Structural Compliance Certificate (Construction)

Description of Inspection: Steel Frame, Steel Trusses and Structural Steel Inspection for Proposed Building 3

Our Reference: Your Reference:	BR200435-SC-Building3-rev02				Level 7 22 Cordelia S South Brisbar	
19/09/2023					T 07 3844 590	00
					www.acor.cor	n.au
Richard Crooke Level 3, 4 Broa	s Construction P/L				ENGINEERS	
Artarmon, NSW					MANAGERS	
,					INFRASTRUC PLANNERS	CTURE
Attention: Ms Ar	ngela Wang				DEVELOPME CONSULTAN	
Dear Angela,						
STRUCTURA	ctural Certification – Build	uilig 3				
Site Details:						
Project Name.	Kingscliff Public School					
Street no. / Stree	•					
Suburb:	Kingscliff	State:	NSW	Postcod	e: 2487	
Description of	Work:		New double st	orey classroo	ms (Building 3)	
Consent:						
SSD No. SSD-8378620-MOD-1		Consent auth	nority:	N/A		
			Dated:		15 June 2023

SITE INSPECTION REPORT

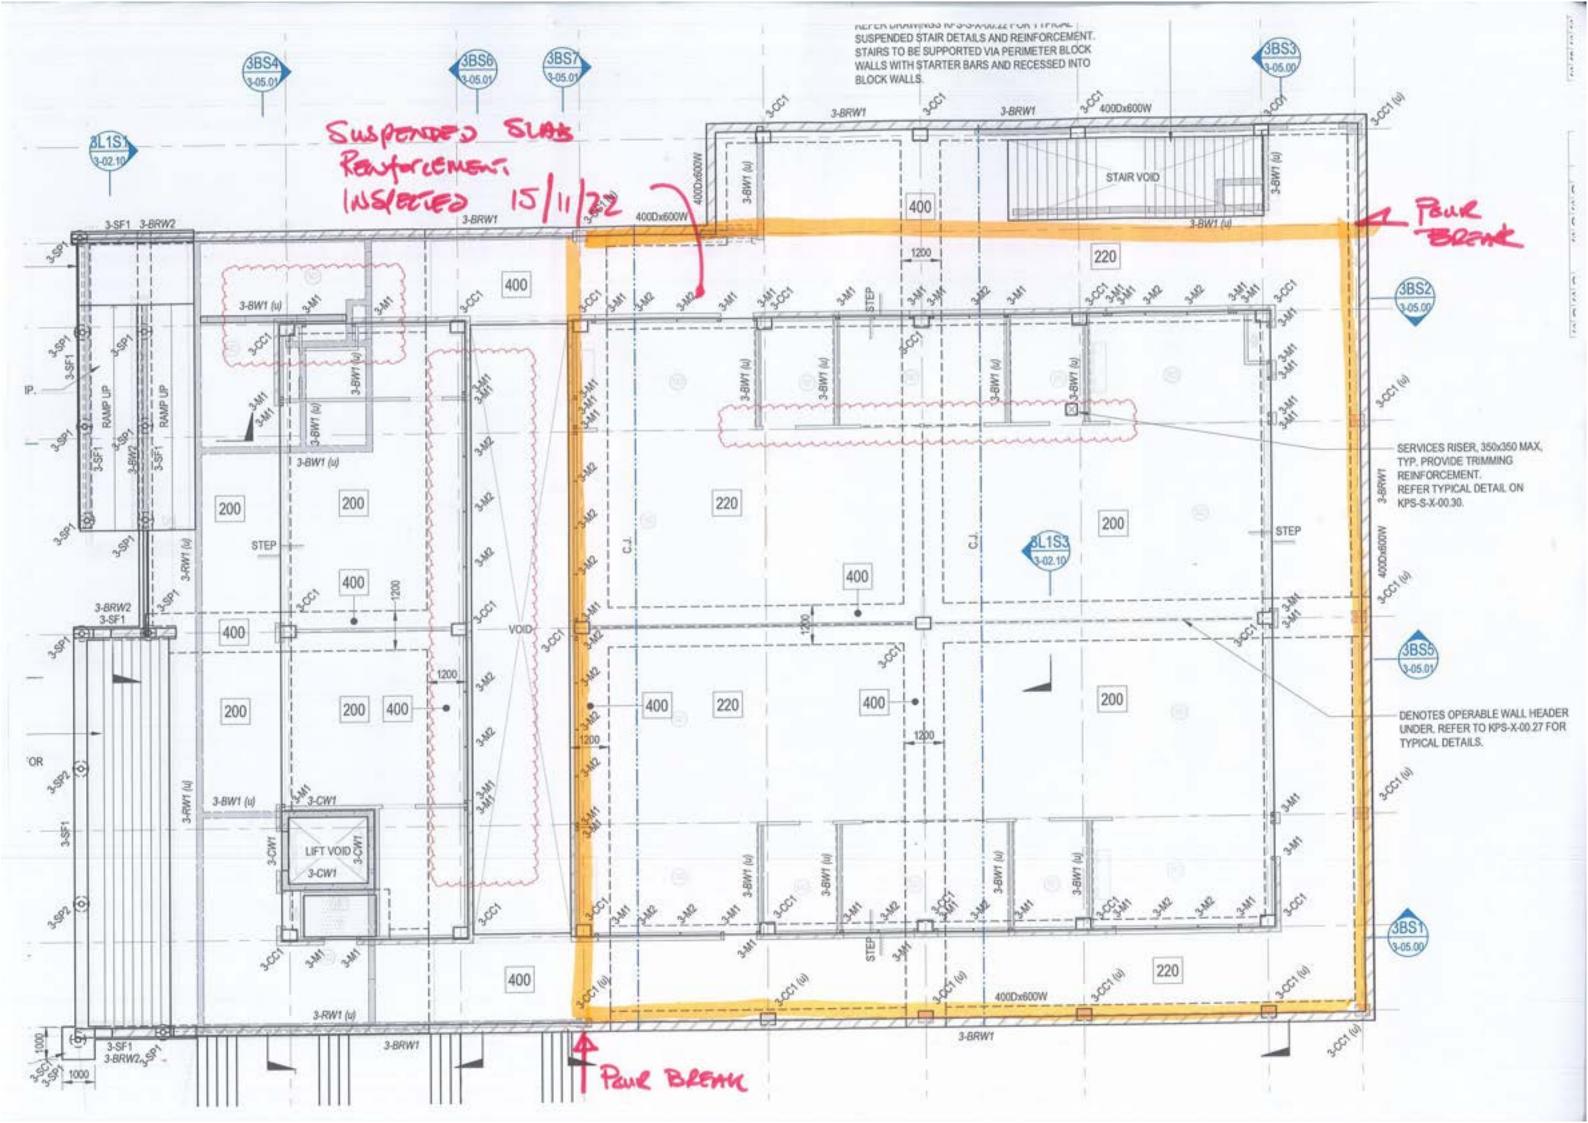
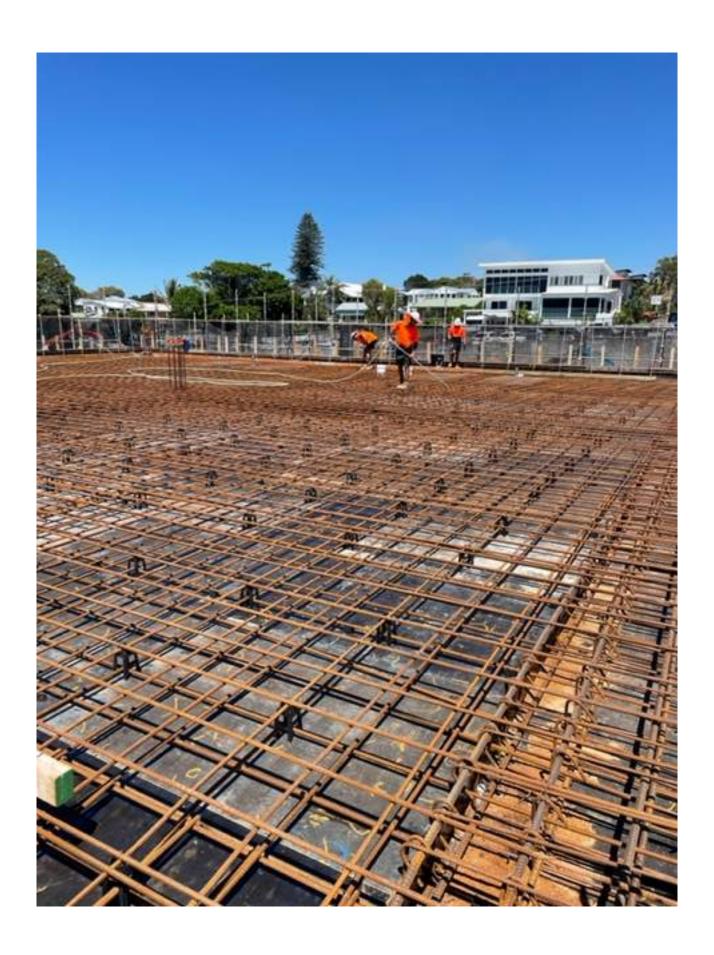
1.
2. FADJUST EXTERNAL BEAM
3. LOVER TO, 45 mm ALI ROUND
4.
5. PHOTOS SENT-AND BUILDER
6. CONFIRMS ENTINE EXTERNAL
7. SCAB & BEAM HAVE 45 mm
8. COVER.
9.
10. CK TO POUR

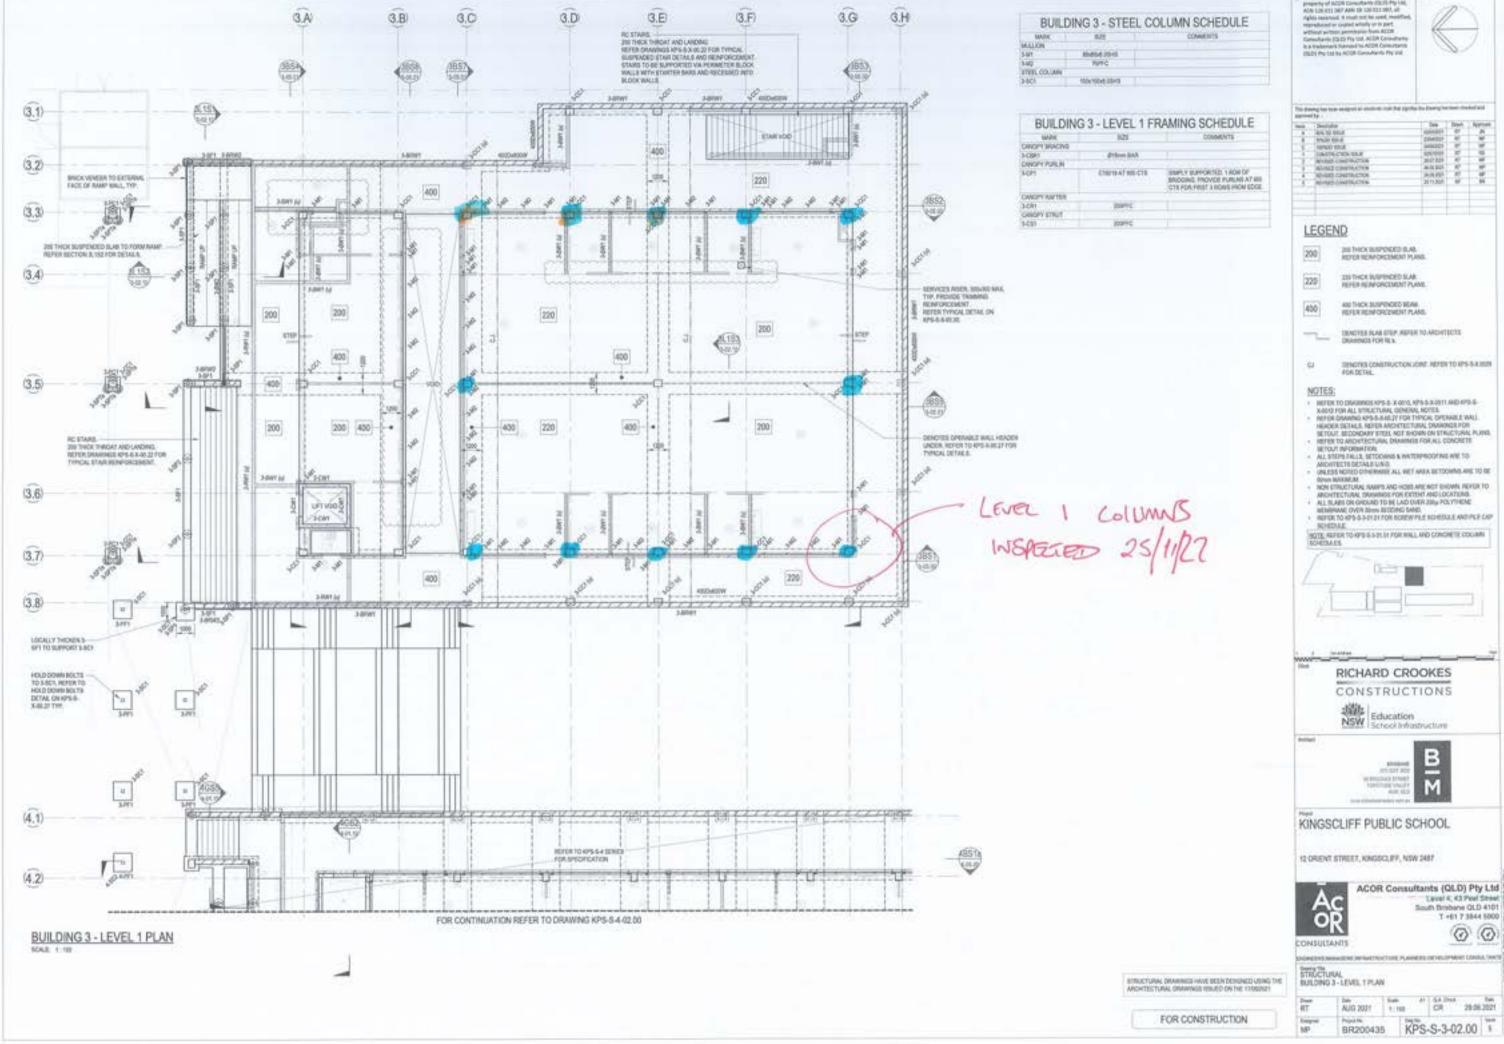
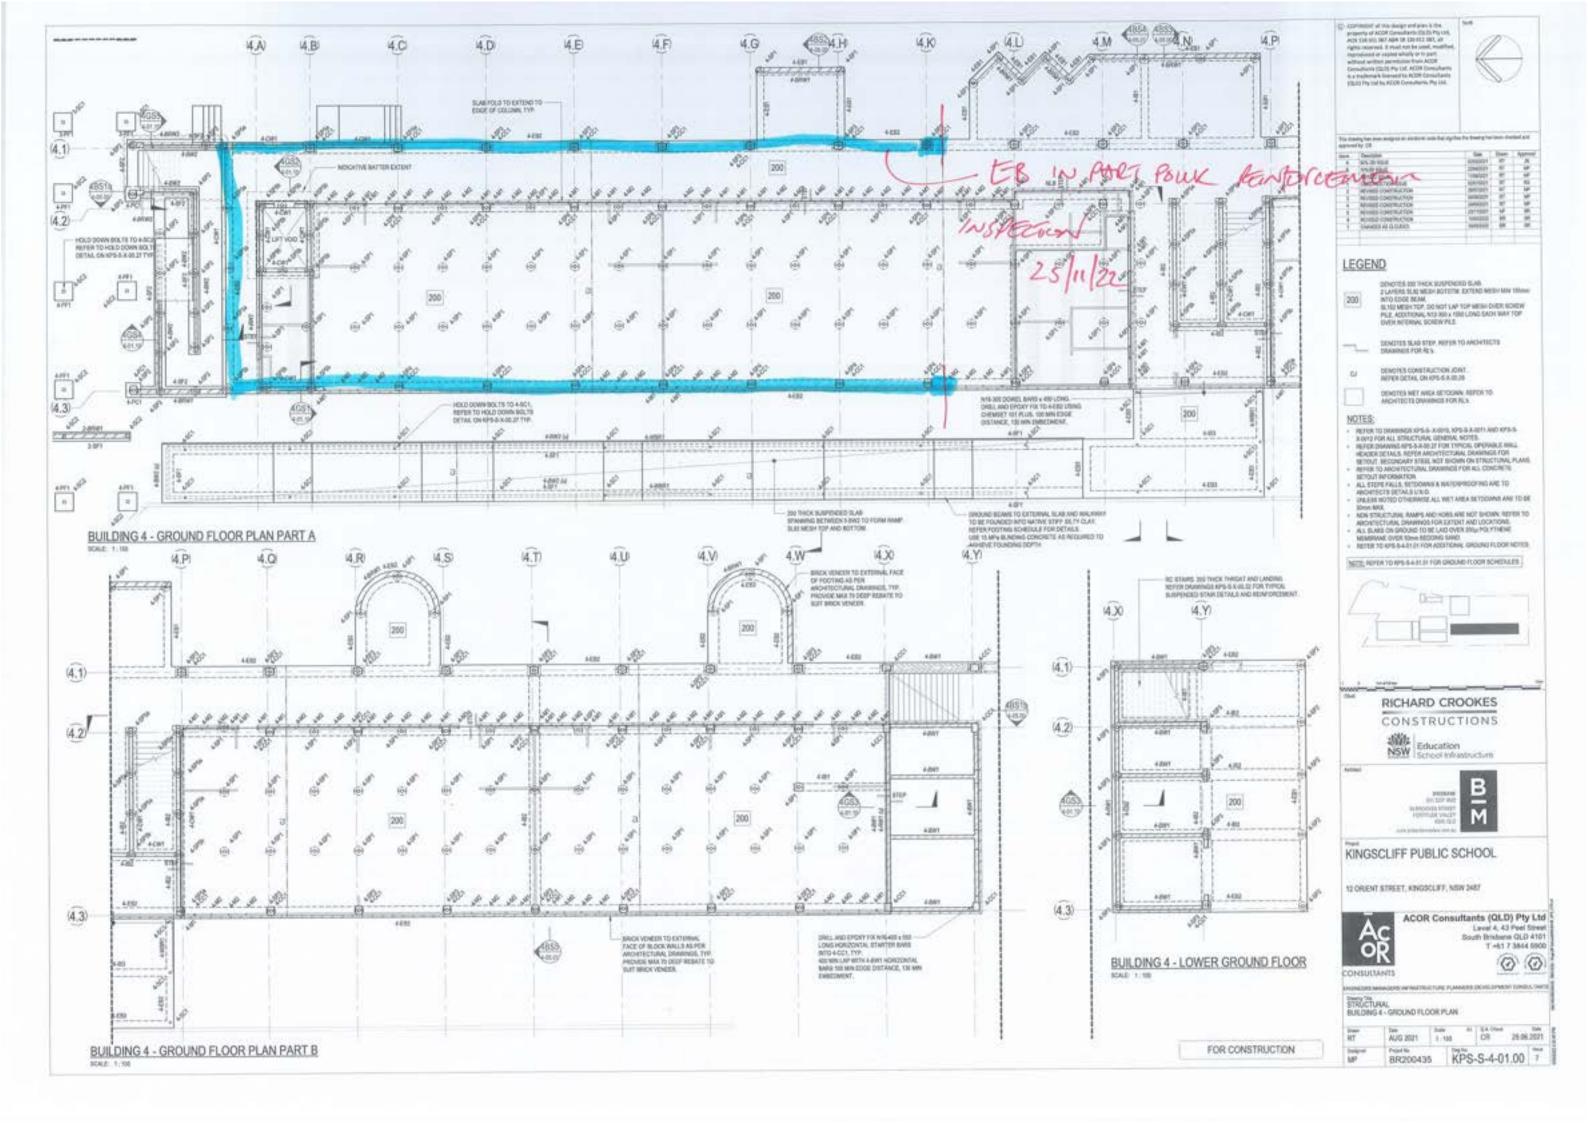
EXTENT REFER ATTACHED MARK-UP
1.
2.X ENSULE CORRECT CORNER BARG
3. AS PEL SHETOULG
4 * ENSURE CORDET LAPPED BARS
5. IN NUMBER AND LENGTH AT
6. POUR BREAK
7 # ENSURE CORDET CONTER-
8. Some TREACHS HAVE COLARSED.
9. * ENSURE CORPECT COLUMN COUER
10.
11. WHON ABOUT COMPLETE CX TO POUR,

Drawing Title STRUCTURAL BUILDING 3 - LEVEL 1 PLAN

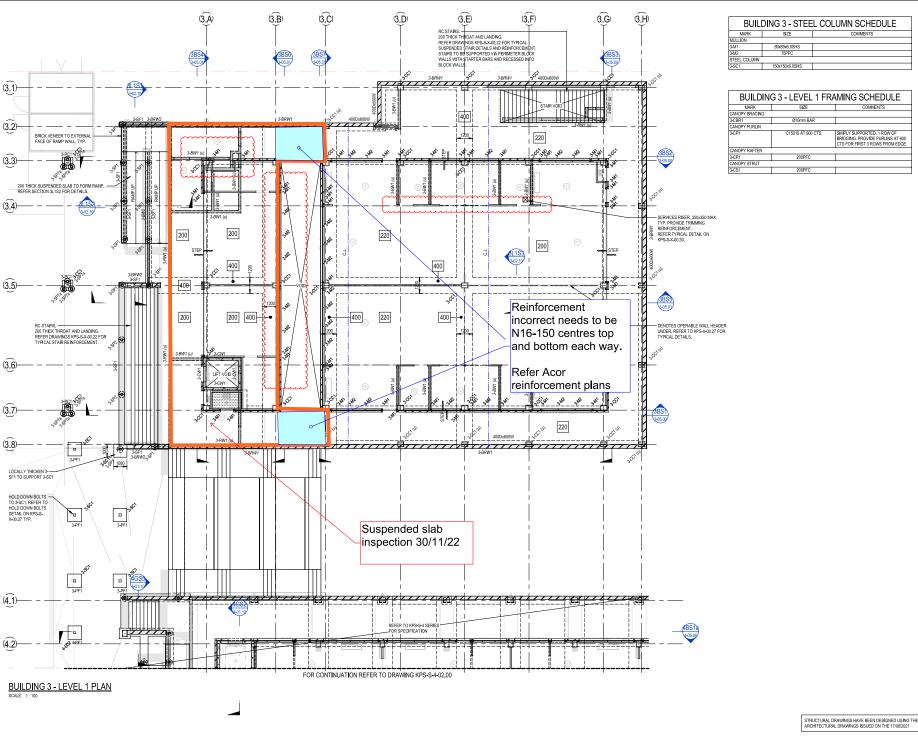
EXTENT REAR ATTACHED MARK-UP
2. * LAYERS B(1) - B(4) to HAVE
3. NIG -150 TOP BOT EACH WAY
2. ** LAYERS B(1) - B(4) +5 HAVE 3. NIG-150 TOP (BOT EACH WAY 4. SOME LAYERS ARE INCORRECT.
5.
6.
7. SEND, PHOTOS PRIOR TO POUR
7. SEND PHOTOS PRIOR TO POUR 8. WHEN COMPLETE —
10. TO CHADO INGINETICO · COM CAU.
11.

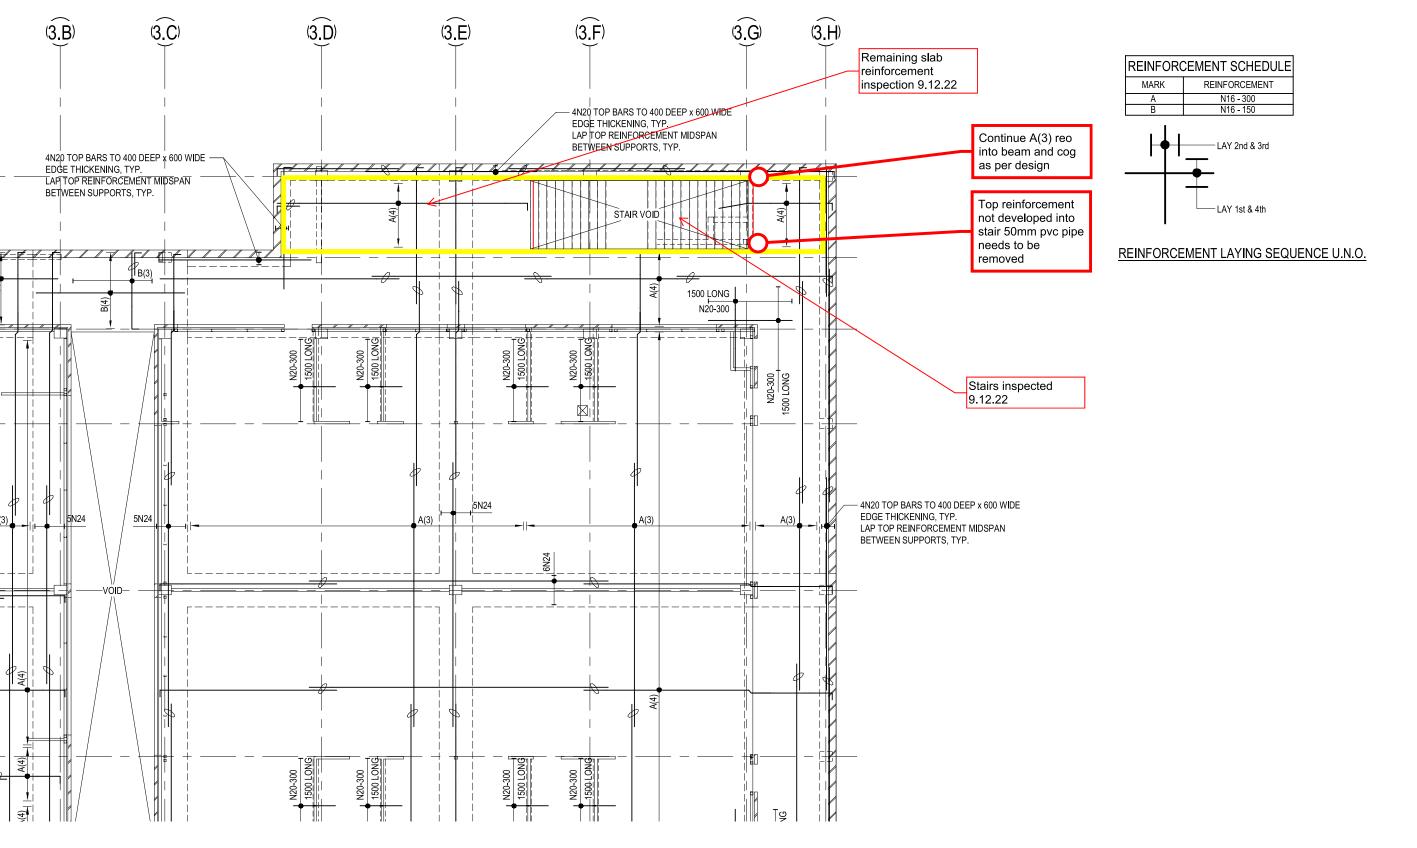
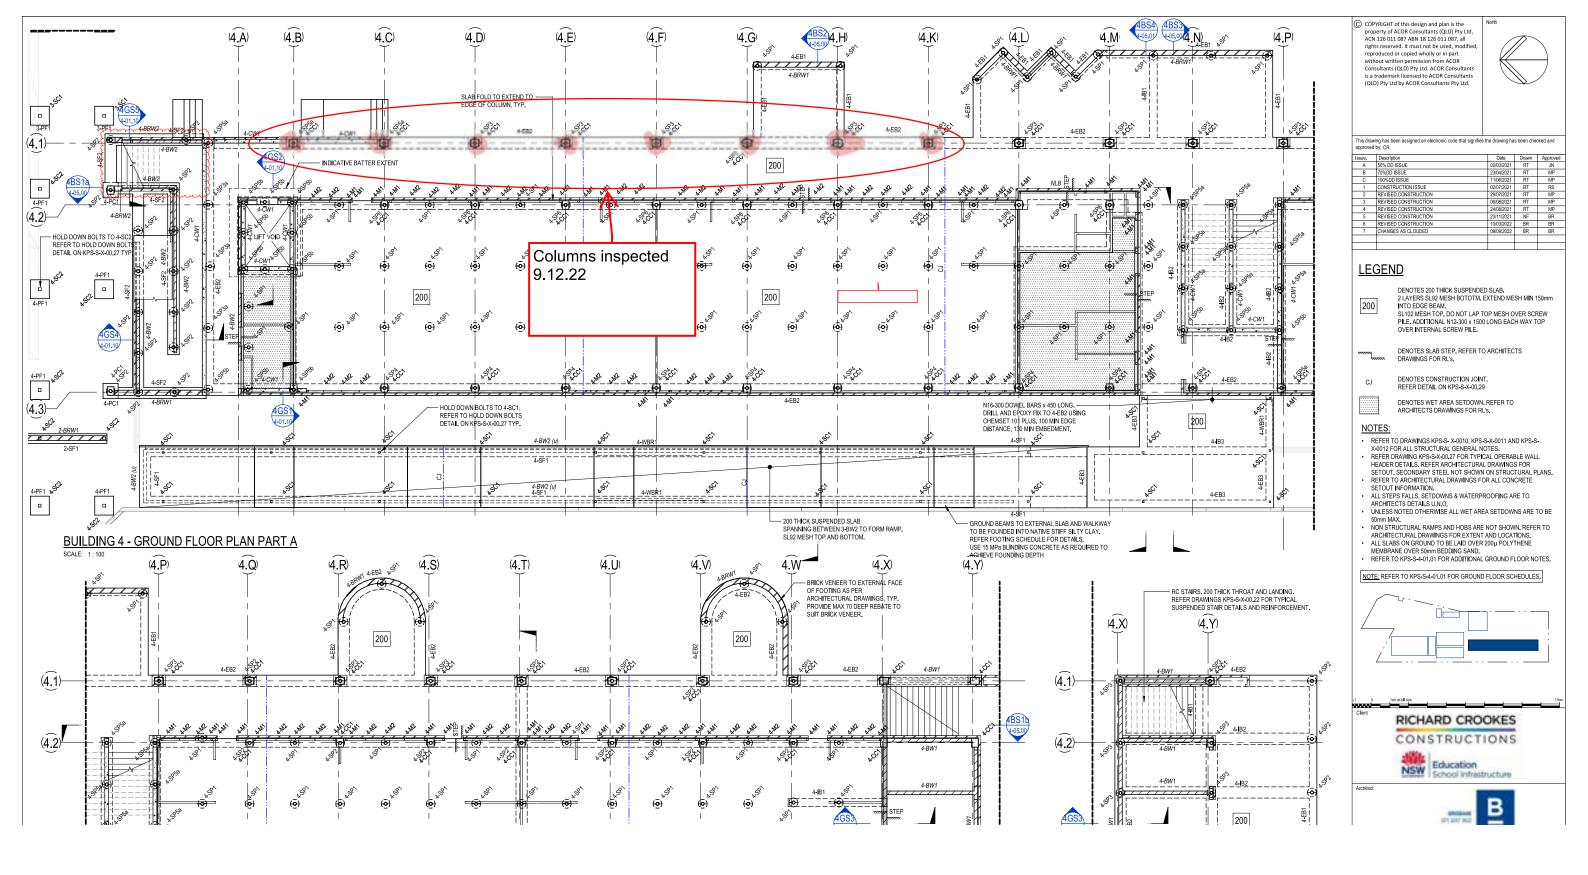
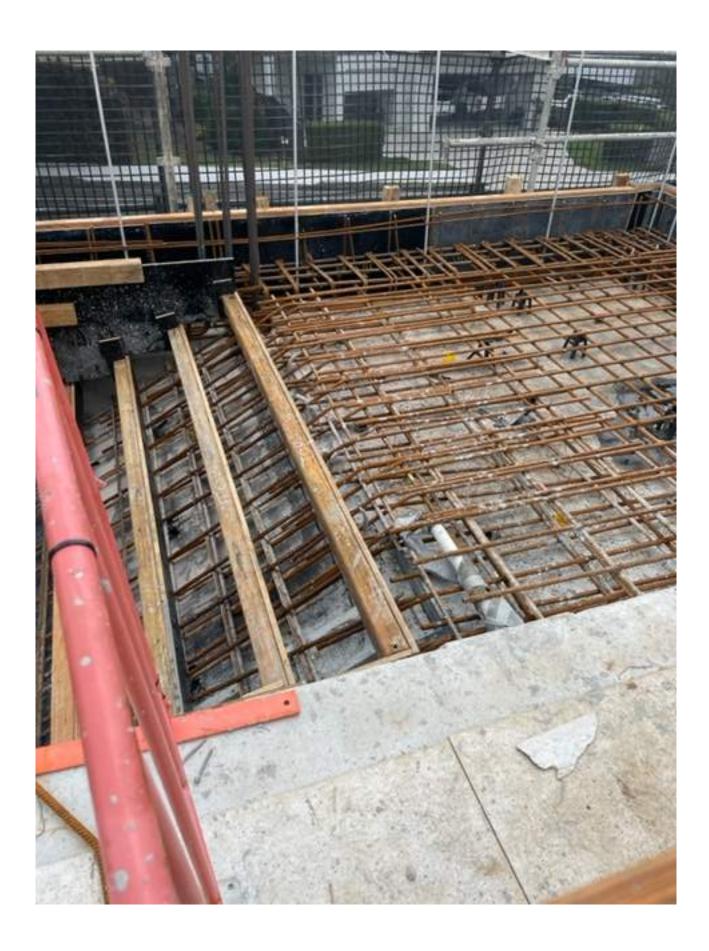
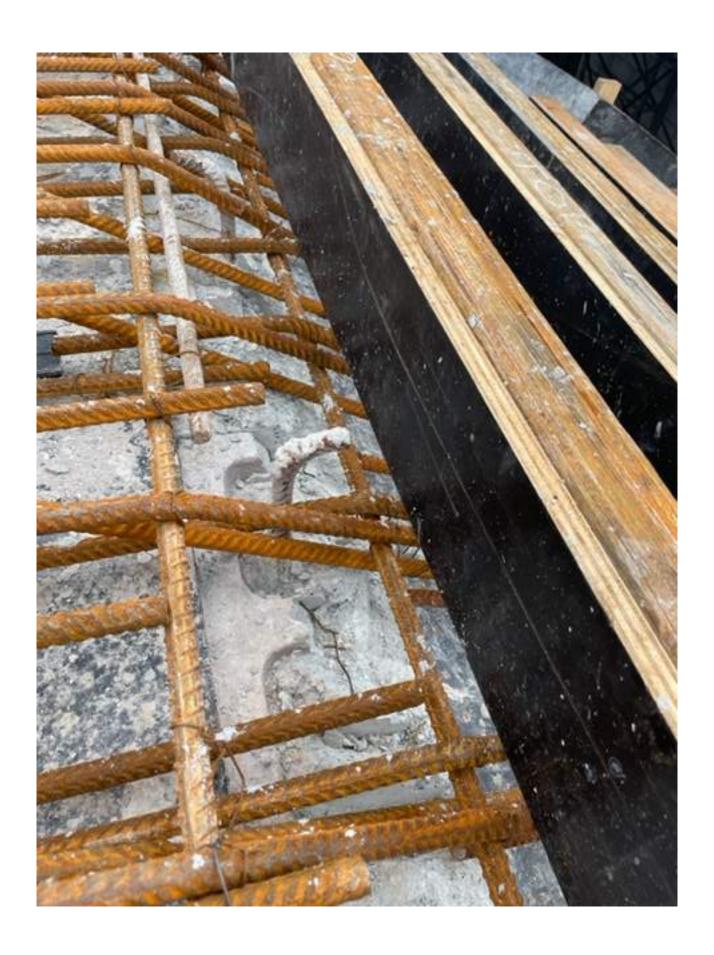
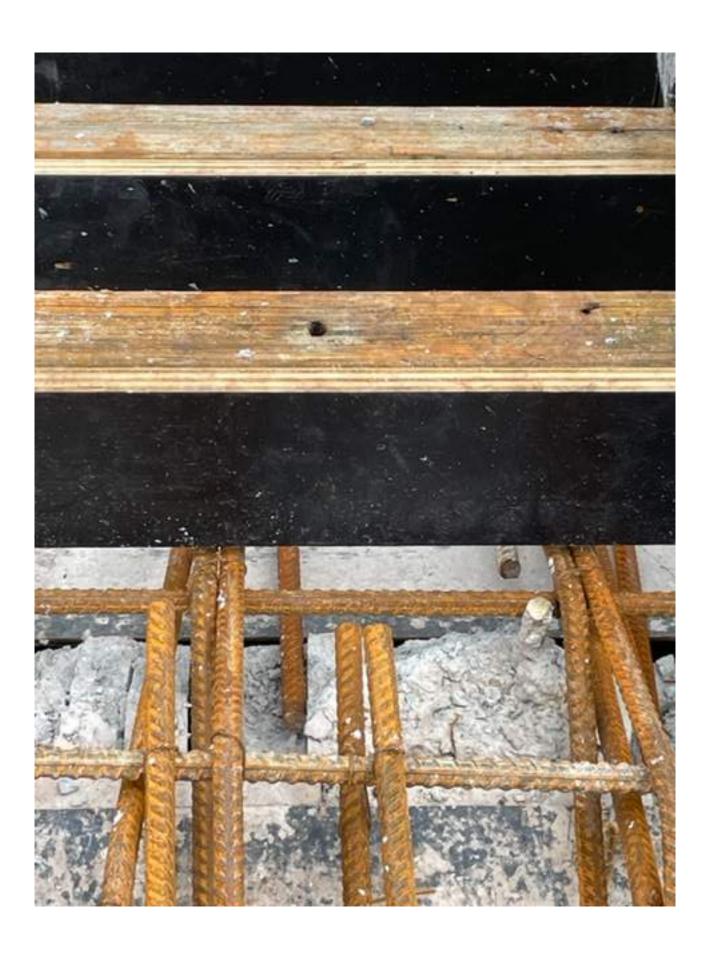
EXTENT REFER MARKUP. STALL THROAT KEN TORC 7. 8. LEDUCE HEIGHT OF SOME SECTIONS OF

STAIR BLOCK WORK AS IT TOO HIGH WTO STAIK Inspecting Engineer Signature:

* ADD DOWERS - AS PER ACIR'S REQUES
